THE BULLETIN

BEAUX-ARTS INSTITUTE OF DESIGN

APRIL·1935

The Critiques appearing in The Bulletin are presented as an unofficial opinion by a member of the jury delegated for this purpose, and should not be interpreted as the collective opinion of the jury.

FIRST MENTION PLACED—L. V. DE WITT, UNIVERSITY OF ILLINOIS ANALYTIQUE III—THE INTERIOR OF A COURTYARD

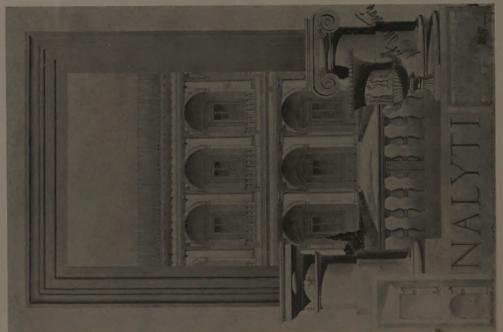
The number of First Mentions was limited and of these three were Placed. The design of L. V. De Witt, University of Illinois, was commended for its fine scale, proportions and dignity. If actually built, it would present a noble façade. E. M. Williams, Yale University, had a well proportioned and interesting grouping of openings with good Renaissance character. A fine solution of a difficult arrangement. D. K. White, Oklahoma Agricultural and Mechanical College, submitted an excellent sheet with a well studied straight-forward solution of the program, well proportioned and simply presented as should be the case with all Analytiques.

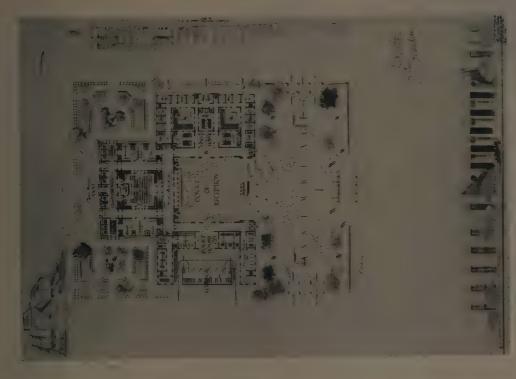
In P. M. Heffernan's (Harvard University) plan, the Council Room was of ample size and capable of being lighted from side courts. The Mayor's and President's offices were well placed and had ample assistants' rooms also well placed. The reception room over the foyer was well located and there was ample vertical circulation. The court rooms all have exterior light at one side with the judges' rooms properly connected. In the Police Station, the central position for the Captain with conference

rooms adjoining were considered well disposed. In this problem the garages were under the terrace with passages to connect with the buildings. On the whole it was a straightforward solution of the problem meeting all the requirements of the program.

SECOND MEDAL, SELECTED--P. M. HEFFERNAN, HARVARD UNIVERSITY
SECOND MEDAL, SELECTED A. WALDORF, NEW YORK CITY
28TH PARIS PRIZE, SECOND PRELIMINARY COMPETITION—A GROUP OF MUNICIPAL BUILDINGS

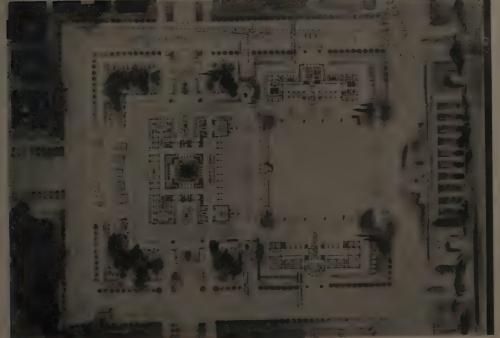
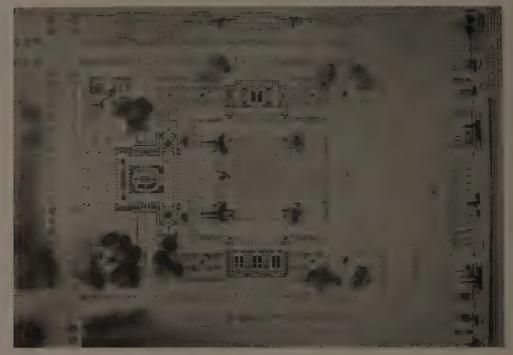
A. Waldorf's projet was somewhat different in that the Police Station and the Court House were connected and form practically one building with the City Hall. There were faults in this plan, however. It received considerable commendation on account of the frank attempt to meet the problem by a difference between the Court House and the Police Station, this unsymmetrical treatment, thus gave better facilities for the Court House and Police Station. An objection was made to one set of court rooms which was without light except as it came from across a corridor.

MENTION, SELECTED-T. T. RUSSELL, UNIVERSITY OF PENNSYLVANIA 28TH PARIS PRIZE, SECOND PRELIMINARY COMPETITION—A GROUP OF MUNICIPAL BUILDINGS MENTION, SELECTED-L. W. SMITH, PRINCETON UNIVERSITY

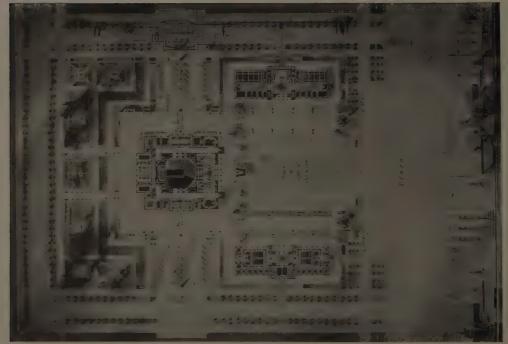
L. W. Smith, of Princeton University, had a somewhat similar arrangement, with the court rooms all lighted at the side. The general disposition of the plan seemed to meet the requirements in a logical manner.

T. T. Russell, of University of Pennsylvania, had a similar scheme but with the reception room on the ground floor instead of over the foyer, with the Mayor's and President's offices directly off the foyer. In this plan the treatment of the Mayor's suite was considered less practical since it is more natural to go through the assistants' offices to reach the Mayor or the President. In the Court House the court rooms were very badly lighted. To adequately light them, the small inner courts should have been very much larger. In general, however, it seemed to meet the problem very satisfactorily.

FHST MENTION PLACED—J. AMORE, BEAUX-ARTS INSTITUTE OF DESIGN
SCULPTURE PROGRAM VI—DOORWAY DECORATION

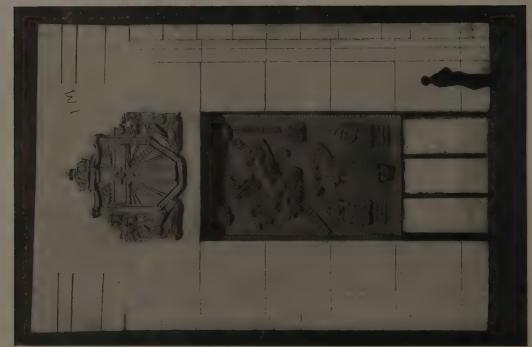
Design by J. Amore shows that the author not only fully grasped the essence of the whole problem, but that he knew how to make the most of it. In this striking design, the properly related stone forms of the shield in no manner compete with the bronze decoration. The scale of this bronze panel suggests that it is but a detail of a large building. The design reads easily and is remembered because of the forceful and contrasting effects produced by the clever handling of light and shade or color. While many designs introduced the "boot" of Italy, mostly a confusing relief map in an already overcrowded background, this design not only used a plain flat background for the "boot," but by surrounding it with a brilliant water motif created a colorful setting for the figure and other symbols of Italy's greatness. Many others had placed objects near the top of the panel in an effort to break the strong horizontal shadow. This one succeeded admirably while most of the others merely destroyed the simple oblong shape of the panel, in some cases even cutting into the stone to produce a "transition" which was not called for.
